Project	IEEE 802.16 Broadband Wireless Access Working Group < http://ieee802.org/16 >
Title	Secure Extended MAC Header Type II
Date Submitted	2007-03-28
Source(s)	Shashikant Maheshwari, Yousuf Saifullah, Yogesh Swami, Haihong Zheng, Adrian Boariu Nokia Siemens Networks 6000 Connection Drive, Irving, TX voice: 972 839 1878 mailto: shashikant.maheshwari@nsn.com
Re:	IEEE 802.16j-07/013: "Call for Technical comments and contributions regarding IEEE Project P802.16j"
Abstract	This document presents a mechanism for securing Extended MAC Header Type II.
Purpose	Propose an efficient signaling acknowledgment operations for IEEE 802.16j
Notice	This document has been prepared to assist IEEE 802.16. It is offered as a basis for discussion and is not binding on the contributing individual(s) or organization(s). The material in this document is subject to change in form and content after further study. The contributor(s) reserve(s) the right to add, amend or withdraw material contained herein.

Secure Extended MAC Header Type II

Figure XX Extended MAC Signaling Header Type II Format

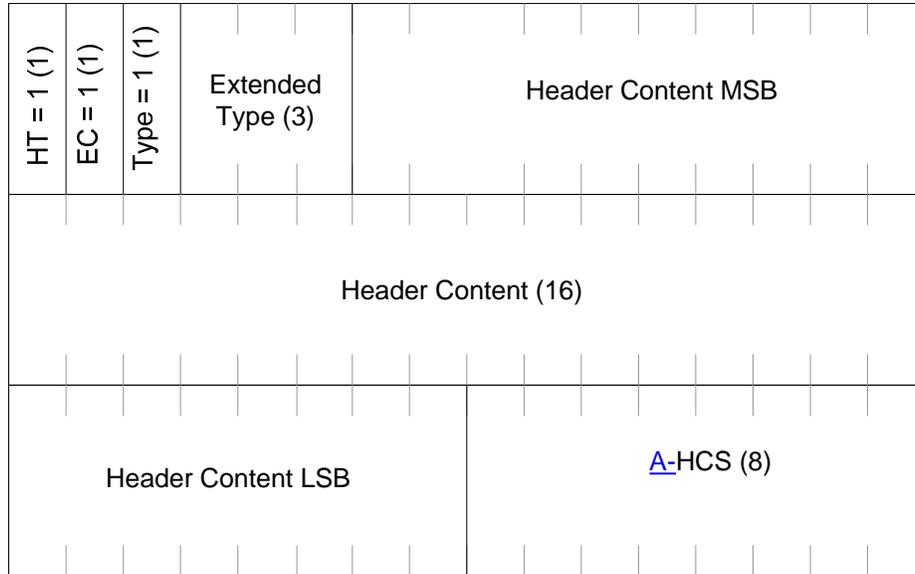
[Change only the HCS field in Figure XX to A-HCS:]
